Conceptual Review Agenda

2060 Perennial Lane (Tract A, The Grove) Day Care Center

Re: 2060 Perennial Ln - Child Care Center

Description of project: This is a request to subdivide land and construct a child care center located at 2060 Perennial Lane / Tract A of the Plat of The Grove at Fort Collins (Parcel# 97233-80-901). Tract A would be subdivided into two 1.9 acre lots. A 9,000 square foot child care center, parking and play yards would be constructed on the northern lot. The site is located in the Employment (E) Zone District. Child care centers are subject to Administrative (Type 1) review in the Employment zone district.

CSURF TRACT A PROPOSED DAYCARE

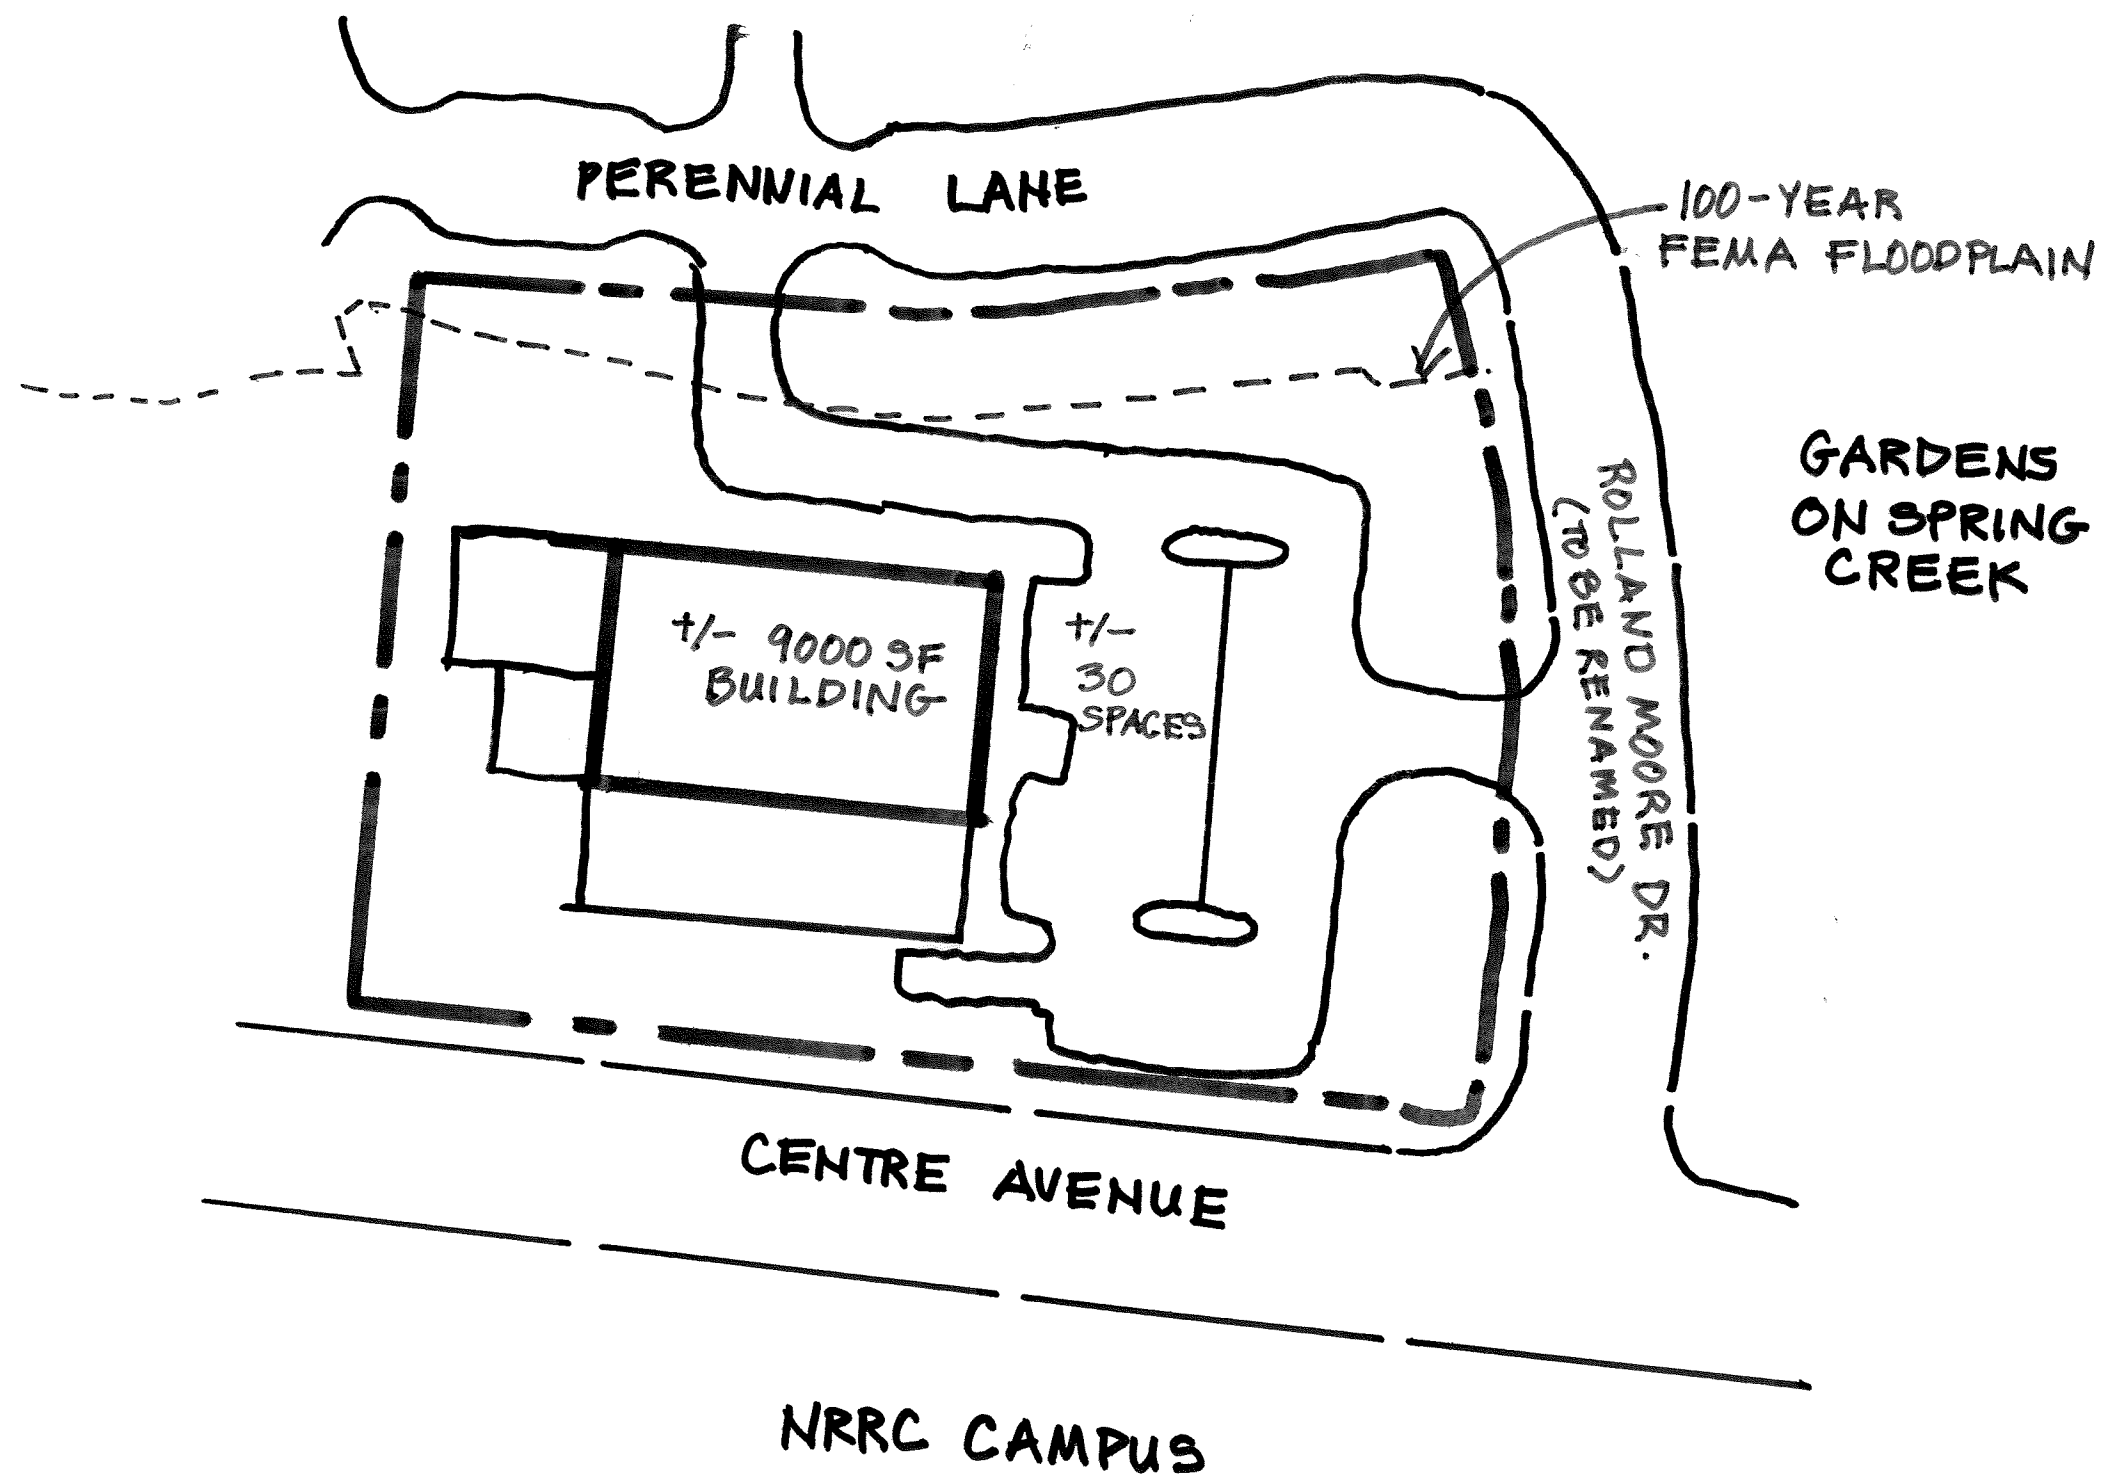
8. LUC 3.5.3 These building design and location standards do apply. Please note that this means the building should be built to the street corner of this corner lot unless you can show compliance with one of the exceptions.

3. The 12-inch sewer extending onto the site may be in conflict with the building; therefore, some modification of the sewer will likely be needed. This sewer could potentially provide sewer to the other portion of Tract A.

2. According to the site plan included with this submittal, the proposed building will not be located in the floodplain; however the access to the site will be in the 100-year floodplain. Since critical use facilities (group homes, residential care facilities, congregate care facilities, daycare facilities, etc.) are not allowed in any portion of the 100-year floodplain, it is imperative that all parts of the proposed building remain out of the floodplain. Although dry access is not required, it is strongly encouraged. At a minimum, an emergency exit onto Centre Avenue or the street to the north will be required. Furthermore, At-Risk population Critical Facilities (daycares) are also prohibited from the 500-year floodplain. Currently, there is not a 500-year floodplain mapped for Spring Creek. However, legislation passed by Congress last year requires a 500-year floodplain to be mapped in the future. It is highly likely that more of the site will be mapped into the 500-year floodplain in the future. Any existing critical facility newly mapped into the floodplain would be considered to be non-conforming at that time. This would mean that the facility could not be expanded to accommodate additional children. We would recommend locating on the subdivided parcel to the south to avoid the critical facility issues with the 100-year floodplain and future 500-year floodplain and to minimize the life-safety risk associated with having a daycare in or near the floodplain.

1. It appears there is an existing tree on site. Please contact Tim Buchanan, City Forester to discuss tree preservation. Coordination with Lindsay Ex, Senior Environmental Planner, regarding the tree is also recommended.

6. The plans for The Grove at Fort Collins indicate an existing 20' sanitary sewer easement that bisects the property and the building as shown would appear to be situated on top of the easement. Vacating an easement (with verification of the ability to do so from Roger Buffington) would require a \$400 TDRF as well as Larimer County recordation costs.

2. The building will need to be built to the corner of Centre Ave and Rolland More Dr. per the standards in 3.5.3(C)(2). Centre Ave is designated at collector street and the building must be located no more than 15 feet from the ROW.
3. At least 1 main entrance must face and open directly to a pedestrian sidewalk connection (Section 3.5.3 (C) (1).
4. The Code requires minimum wall articulation breaking up exterior walls longer than 30' (Section 3.5.3(E)(2) (a). Please call out length, colors and materials on the elevations. The entrance must be clearly defined. The architecture must have a distinguishable base treatment as well as a top treatment such as a detailed cornice (show detail with projection) or in the case of a sloped roof, bracket detailing should be included
